REMARKS

Appendix A
VERSION WITH MARKINGS TO SHOW CHANGES MADE

FIG. 11

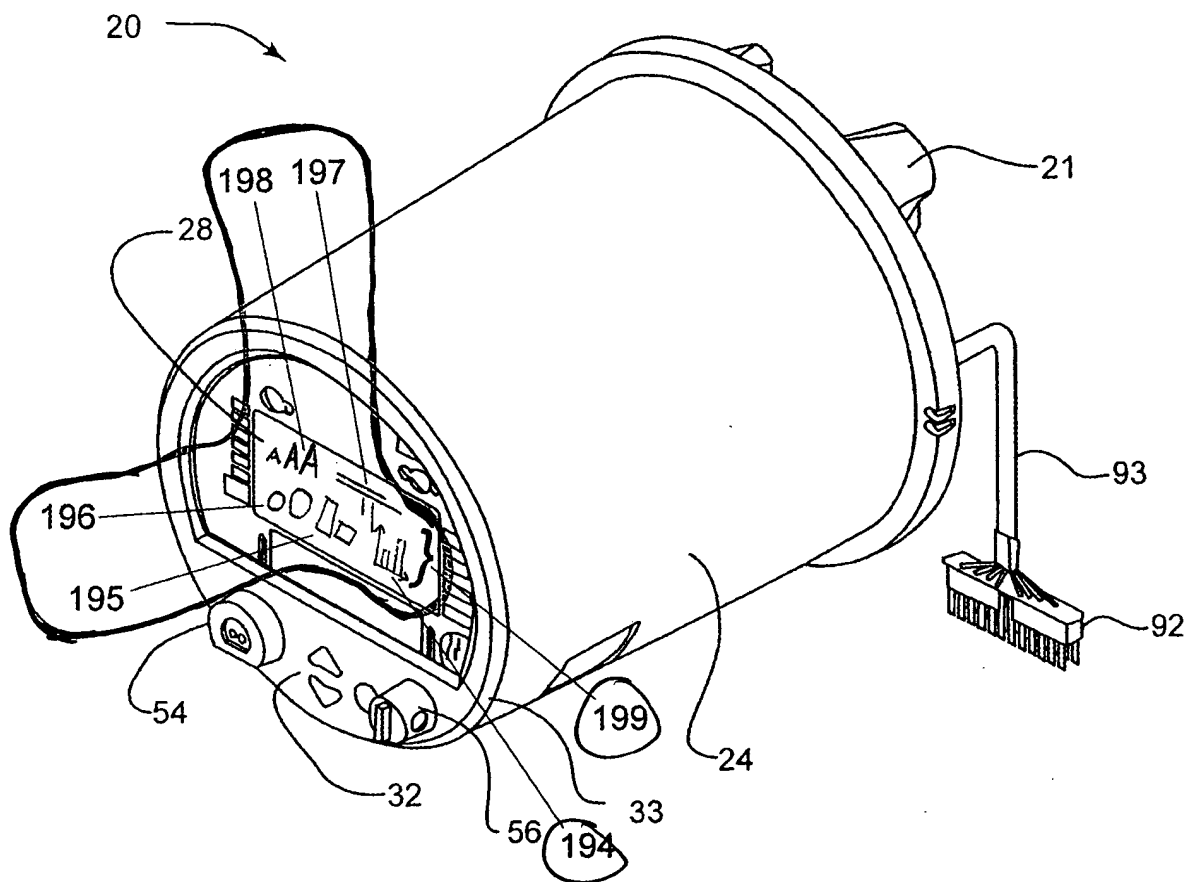
The drawings stand objected to under 37 CFR 1.83(a) as failing to show all features of the invention claimed. Figure 11 has been amended in the drawings to better describe the claimed features. The figure amendment is supported by the specification on at least page 10, lines 9-12 and page 11, lines 20-22. No new matter has been added.

Claims 1-33 stand rejected under 35 U.S.C. 112 as containing matter which was not described in the specification in such a way as to enable one skilled in the art to which it pertains, or with which it is most nearly connected, to make and/or use the invention. The examiner indicated that it was unclear what comprises the "graphic user interface" or how it operates.

As indicated above, the "graphic user interface" or "GUI" is shown in the amended figures. In addition, the applicants submit that the "GUI" is sufficiently described in the description to enable one skilled in the art to make and/or use the invention. Reference is especially made to the description from page 10, line 3 to page 12, line 20. Therefore, applicants respectfully request that the rejection of claims 1-33 be withdrawn.

(Twice Amended) Referring to FIGS. 1-3, the S-base and A-base revenue meters' cover 24, and the Switchboard revenue meter's cover 48, are at least partially transparent. The transparency permits viewing of the meter's display 28 including a graphic user interface (GUI) 199 (Fig. 11) [(not shown)] without having to remove the cover 24. As mentioned above, the meter cover 24 provides the context adaptable input device such as the keypad 32 for interacting with the revenue meter while the meter cover 24, 48 remains in place. Artisans will appreciate that the keypad 32 can be replaced with other context adaptable input devices, such as a touch screen 1100, a mouse 1110, a track ball 1120, a light pen 1130, a membrane switch 1140, joystick 1150, dial 1160, or other similar devices.
